Ref #: SR500LFE-01-VID

Title: TX-SR500

Classification: Mandatory Service Bulletin

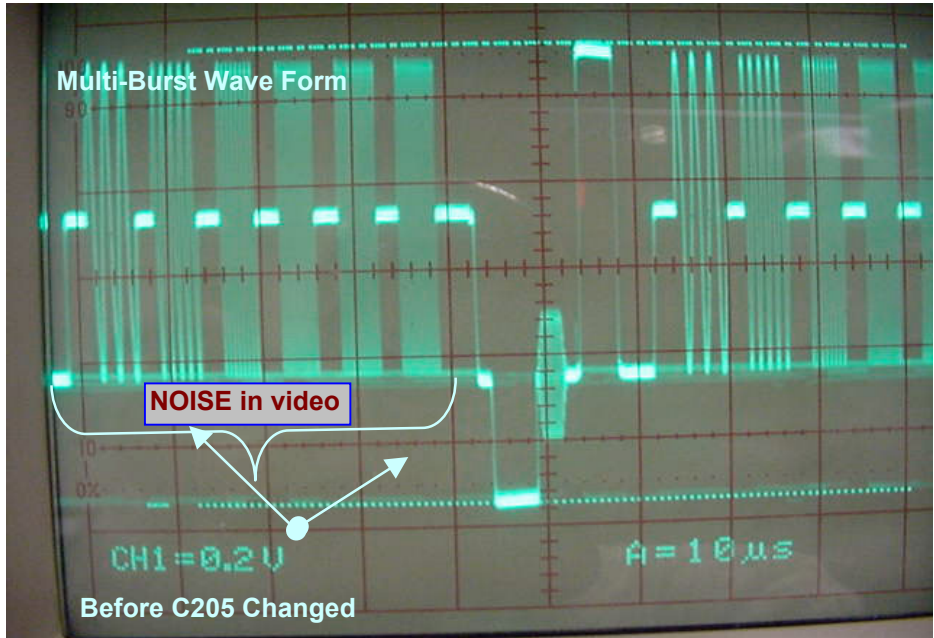
Symptom: 1) In some units, LFE (SW Setting) Mode #3 may not have any out put when playing DD material.

Solution: 1) In some units improper software was used for System Control Microprocessor (Q7008). Follow the table to establish remedy only for those units having microprocessors considered having "No LFE (Mode-3)".

PN (Q7008)	Description (Q7008)	Status	Memo
22241765R3	UPD784225GC-166	GOOD	Need Not Replace
22241842R3	UPD784225GC-176	No LFE (Mode-3)	NLA
22241881R3	UPD784225GC-183	No LFE (Mode-3)	NLA
22241957R3	UPD784225GC-215	GOOD	Available, Supplied

When addressing service for above described problem, check and confirm that the microprocessor Q7008 suffix is other than xx-166 or xx-215. If so, please submit request to replace PN #1A928501-1A and perform service.
